Office Action Summary	Application No. 10/694,147	Applicant(s) WANT ET AL	
	Examiner Korie H. Chan	Art Unit 3632

DETAILED ACTION

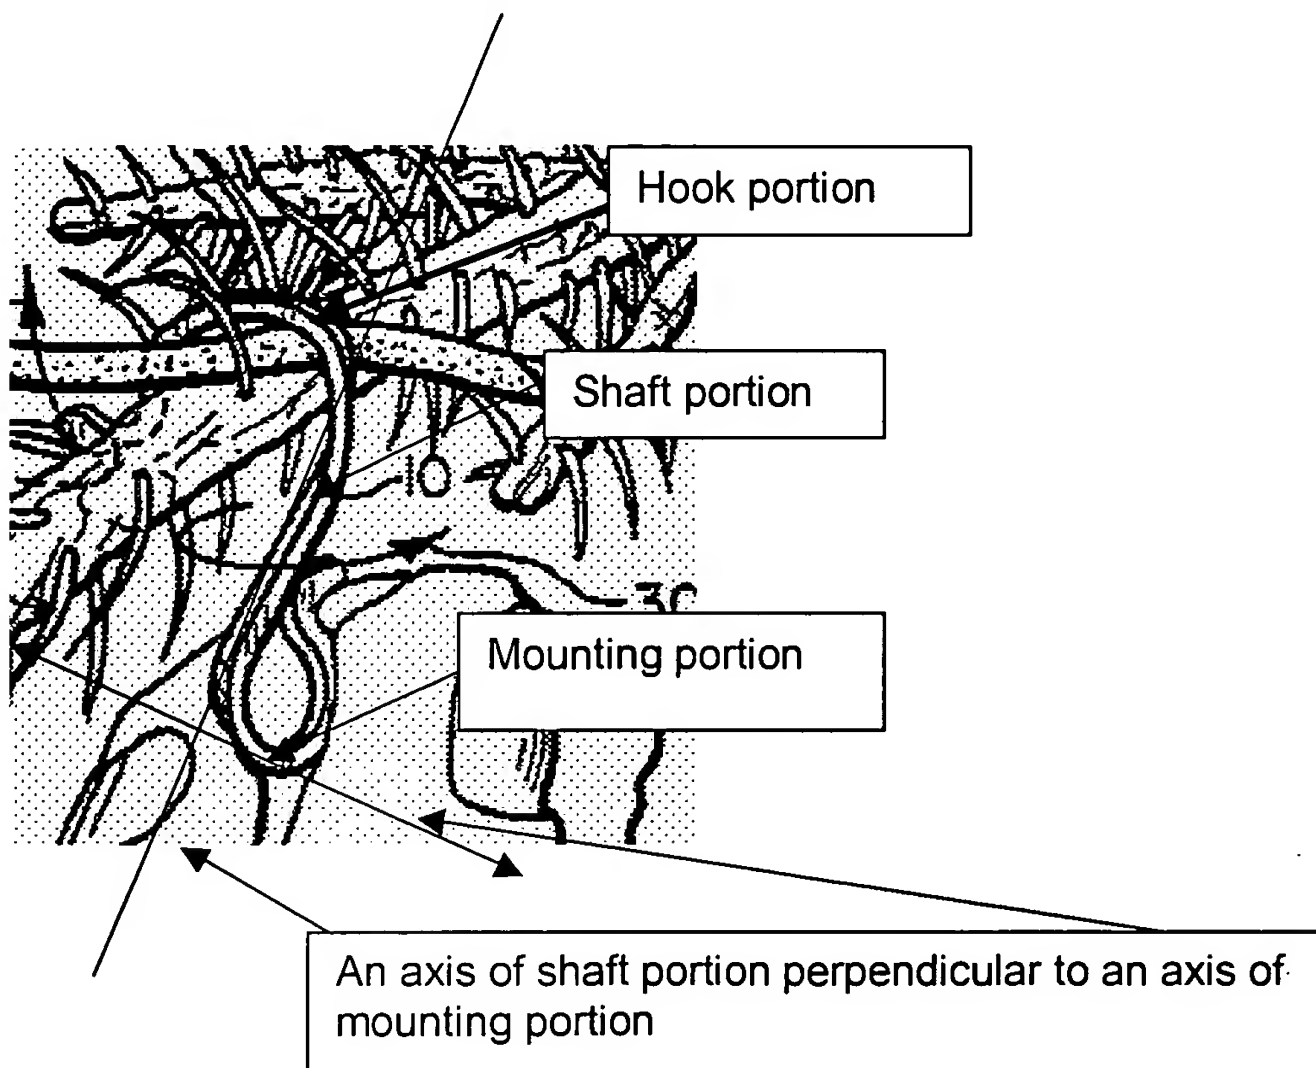
Claims 1-3 and 6-12 are rejected under 35 U.S.C. 102(b) as being anticipated by Swenson et al (US patent no. 5,575,446). Swenson disclosed all the claimed features of applicant's invention as demonstrated below.

Applicant's argument filed 1/5/2006 have been fully considered but are found not persuasive. Regarding Swenson et al, applicant argues that Swenson does not disclose "hook portion is positionable in a plane of the mounting portion. Examiner respectfully disagrees. Swenson in figure 3 clearly shows the hook portion 15 positioned in a plane of the mounting portion (12). And the longitudinal axis of the mounting portion as illustrated above is perpendicular to an axis of the shaft. Accordingly, the rejection stands.

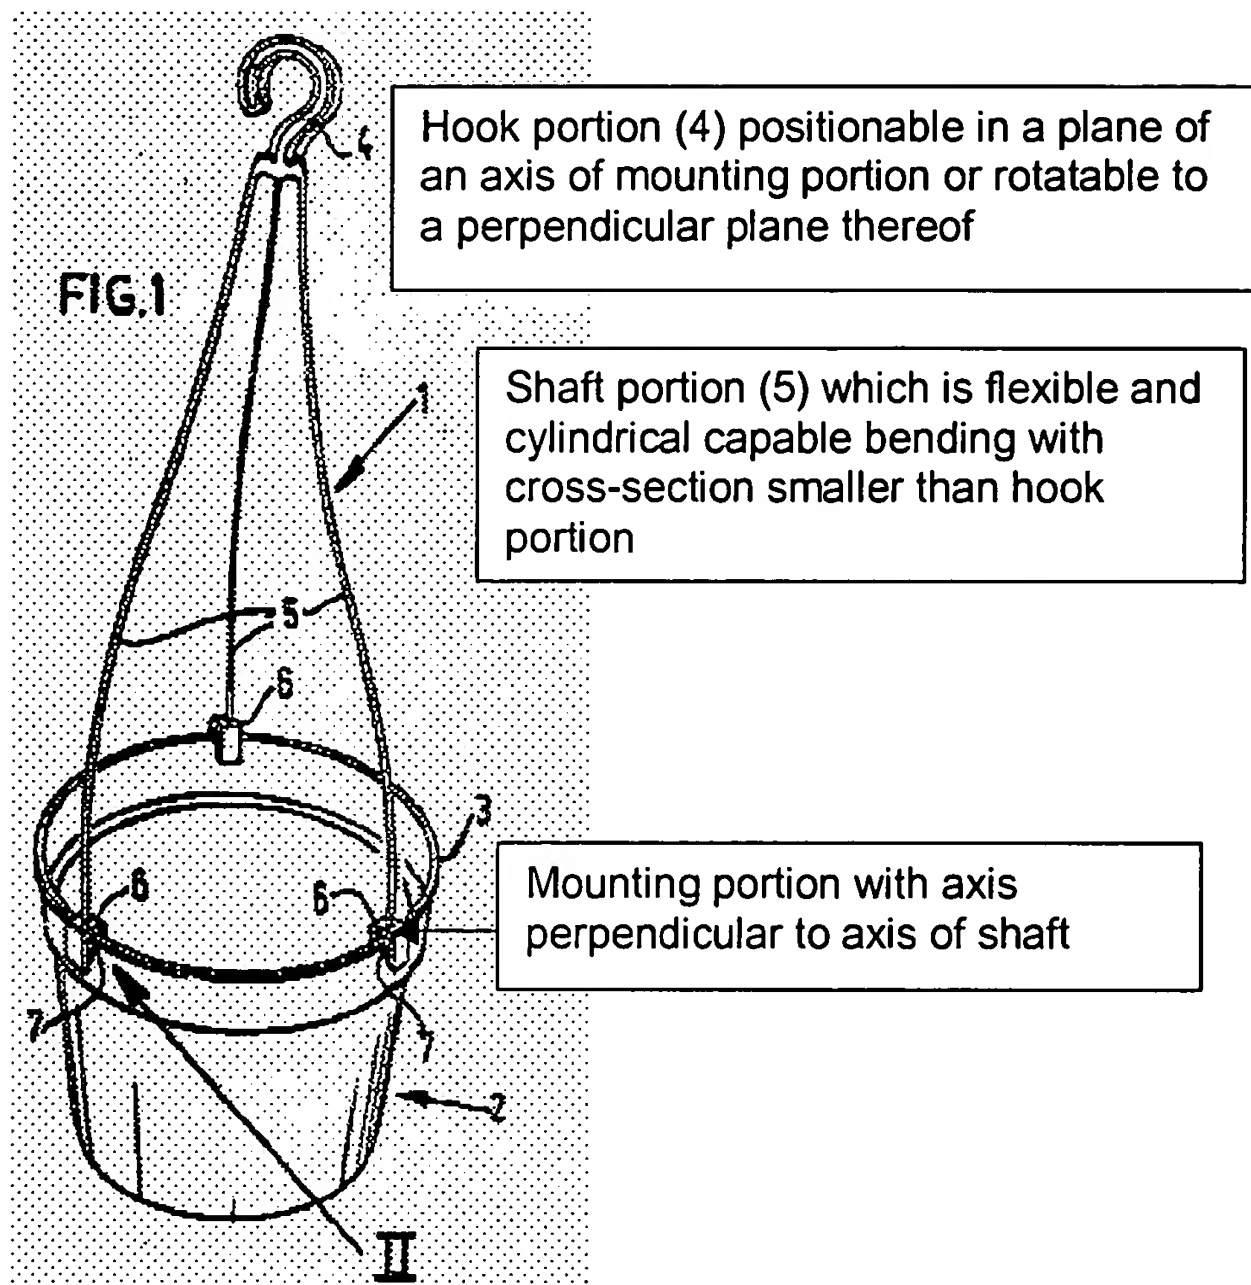
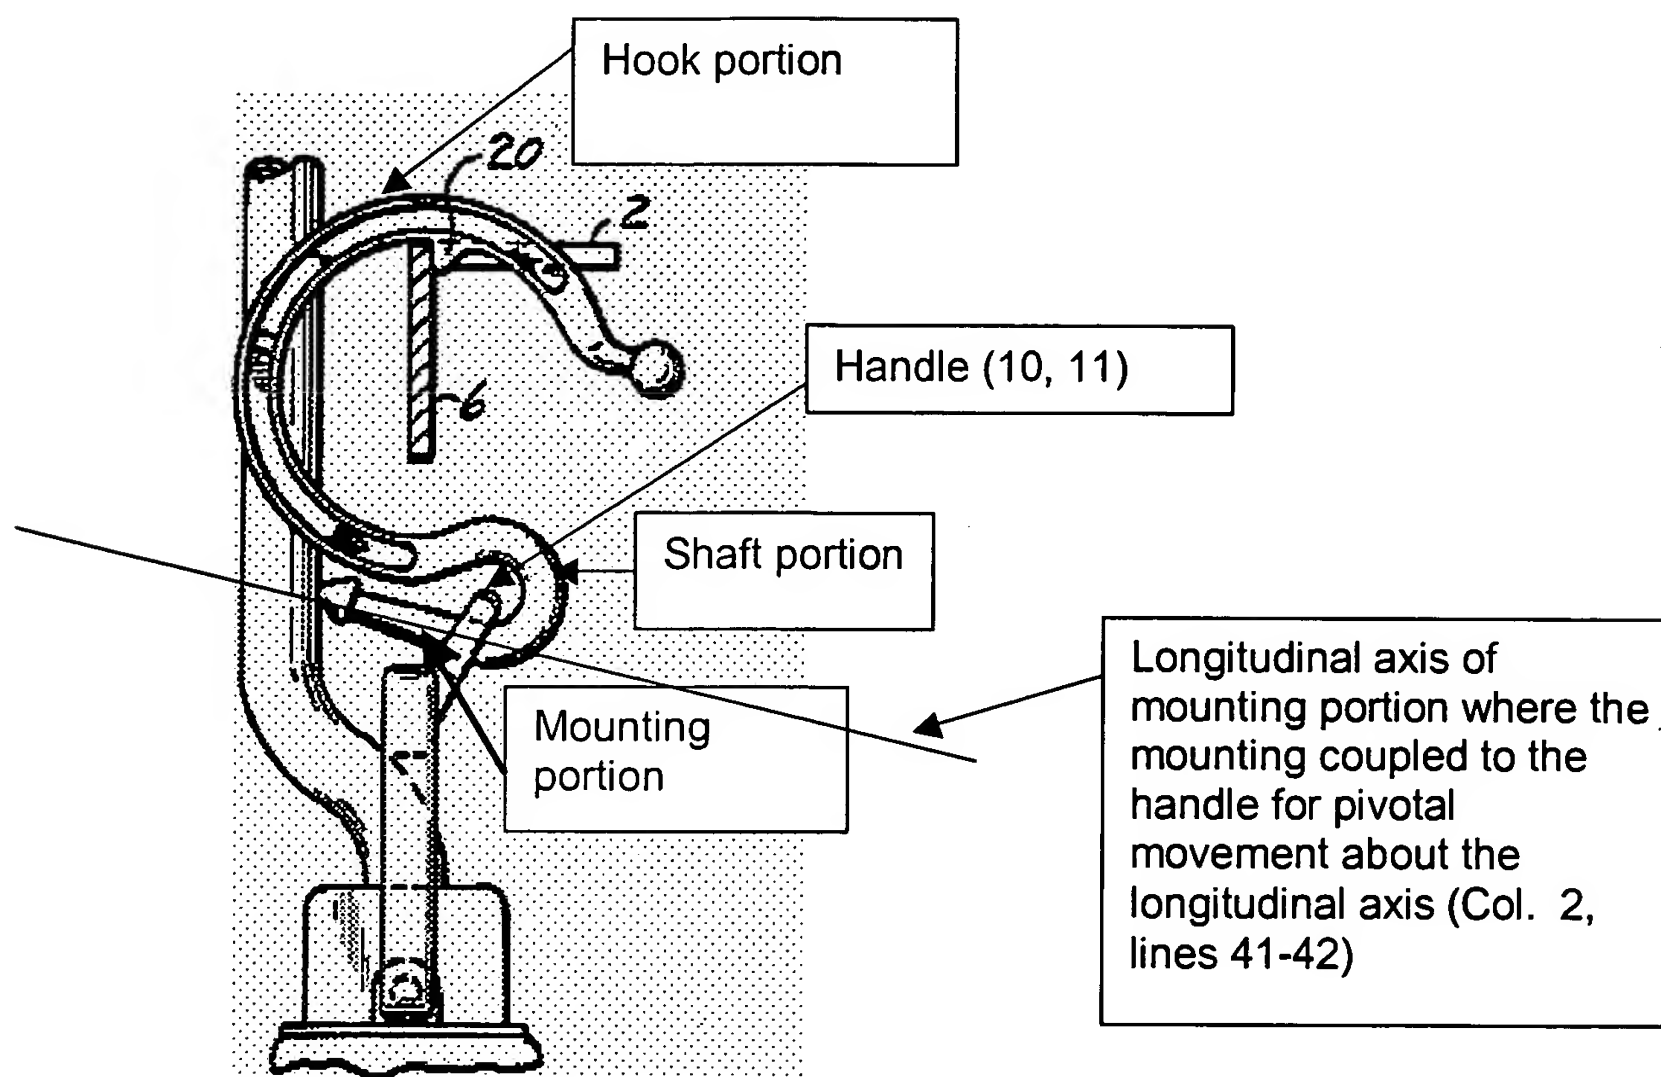
Claims 1-12 are rejected under 35 U.S.C. 102(b) as being anticipated by Wijsman (US patent no. 4,440,371). Wijsman disclosed all the claimed features of applicant's invention as demonstrated below.

Applicant's argument filed 1/5/2006 have been fully considered but are found not persuasive. Regarding Wijsman, applicant argues that Wijsman does not disclose "mounting portion...configured for mounting said apparatus for movement with respect to the medical device" where Wijsman does not show the carrying members (6) are adapted for movement with respect to the pot. Examiner respectfully disagrees.

Wijsman shows the mounting portion (item 6) is configured for mounting the apparatus (the hanger) by gripping the pot and when the pot is gripped, the apparatus for hanging can be moved via the flexible shaft (1) and the fact the pot is gripped by item 6 with respect to the device (or pot).

Applicant argues that Wijsman's carrying member (item 6) does not have longitudinal axis or axis of rotation. Examiner respectfully disagrees. The "longitudinal axis" is not claimed as "axis of rotation" in claims 1-12 and such argument is irrelevant. Regarding longitudinal axis, the carrying member 6 of Wijsman certainly has a longitudinal axis. An axis is an imaginary line through the device. Wijsman's longitudinal axis is any horizontal axis extending through the item 6 along the plane of the hook (4) which also meets applicant's limitation that "hook portion is positionable in a plane of the mounting portion. Accordingly, the rejection stands.

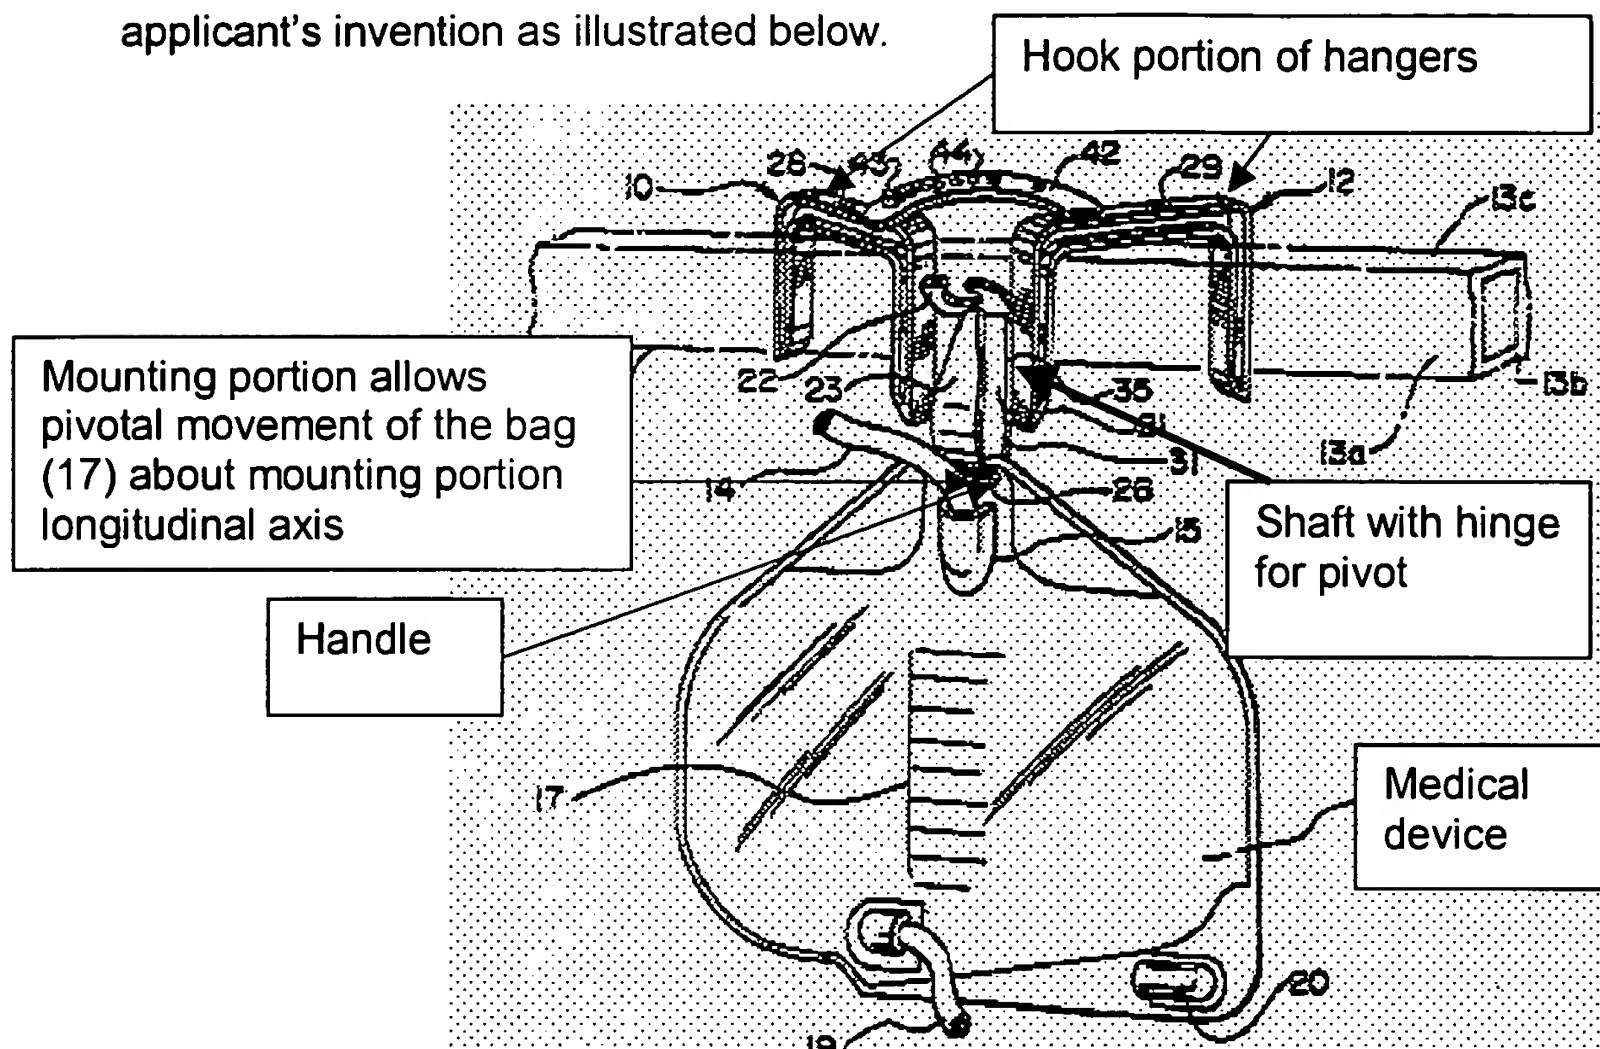
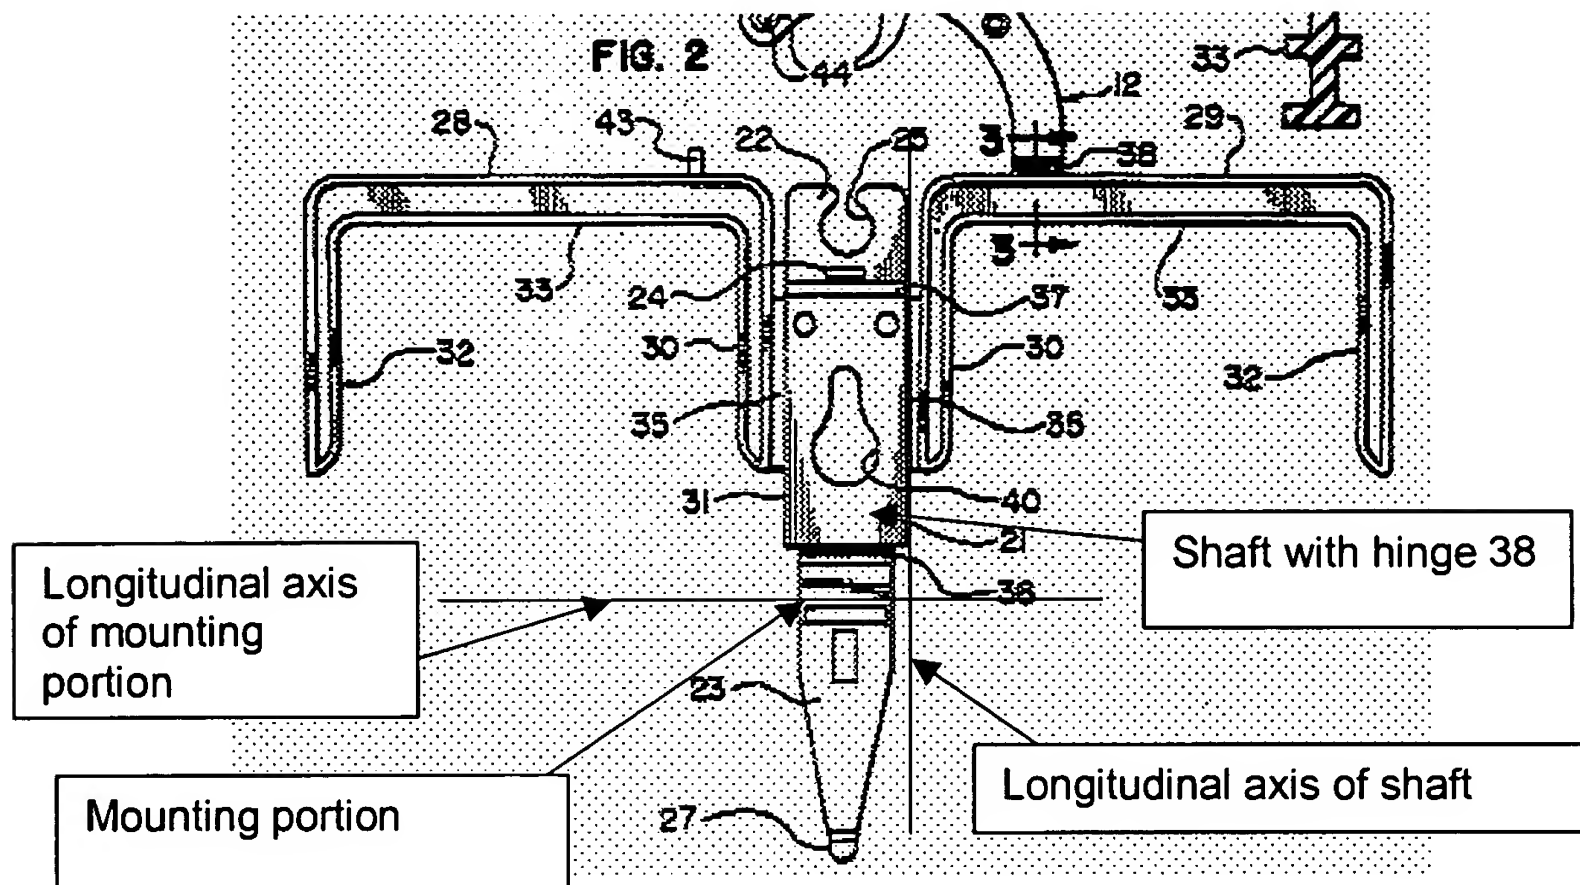
Claims 13-15 and 18 are rejected under 35 U.S.C. 102(b) as being anticipated by Rhodes (US patent no. 5,373,799). Rhodes disclosed all the claimed features of applicant's invention as illustrated below.

Applicant's argument filed 1/5/2006 have been fully considered but are found not persuasive. Regarding Rhodes, applicant argues that Rhodes does not disclose "mounting portion coupled to an end portion of said elongated shaft and coupled for pivotal movement with respect to the medical device about a longitudinal axis of the mounting portion" and "elongated shaft of said hanger configured to permit rotation of said hook portion with respect to said mounting portion of said hanger about a longitudinal axis of the elongated shaft". Examiner again respectfully disagrees. Rhodes clearly discloses "mounting portion (the portion of the strap where the handle of medical bag is hung) coupled to an end portion of said elongated shaft (21 along with its hinge 38) and coupled for pivotal movement with respect to the medical device about a longitudinal axis of the mounting portion (the handle of the medical bag and the strap mounting portion are foldable or pivotable about each other at the longitudinal axis, see illustration above)" and "elongated shaft (21 along with its hinge 38) of said hanger

configured to permit rotation of said hook portion with respect to said mounting portion of said hanger about a longitudinal axis (extending through the hinge) of the elongated shaft". Accordingly the rejection stands.

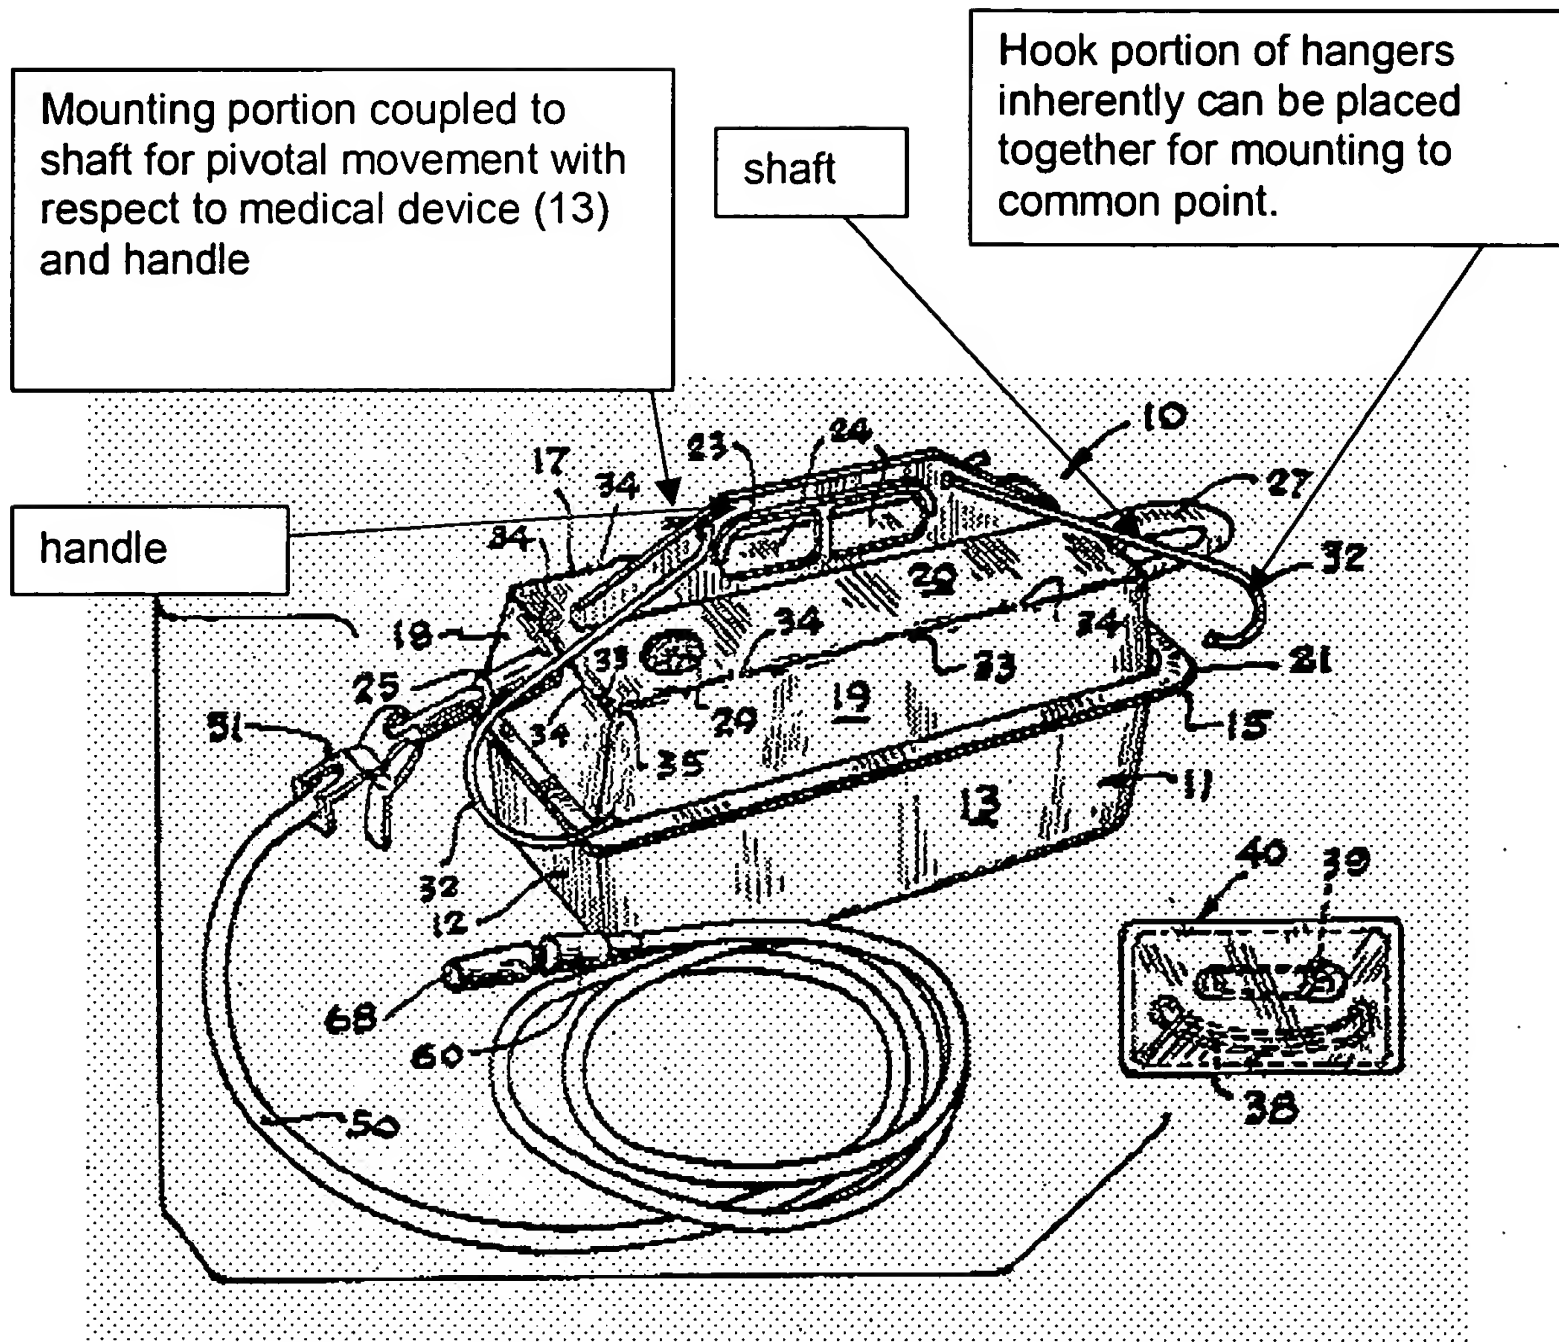
Claims 19, 21 and 22 are rejected under 35 U.S.C. 103(a) as being unpatentable over Chittenden et al (US patent no. 3,690,315) in view of Koresko (US patent no. 5,224,607). Chittenden et al disclosed all the claimed features of applicant's invention (as illustrated below) except for the hook portion rotate with respect to mounting portion. Koresko teaches in a hanger of providing a hook portion (3) and mounting portion (5) wherein the hook portion rotates relative to the mounting portion to overcome prior art deficiencies by allowing for "capture of multi-positioned supports" (col. 4, lines 14-20) . It would have been obvious to one of ordinary skill in the art to have made Chittenden's hook portion rotatable relative to the mounting portion to permit capture of multi-positioned supports as taught to be desirable by Koresko.
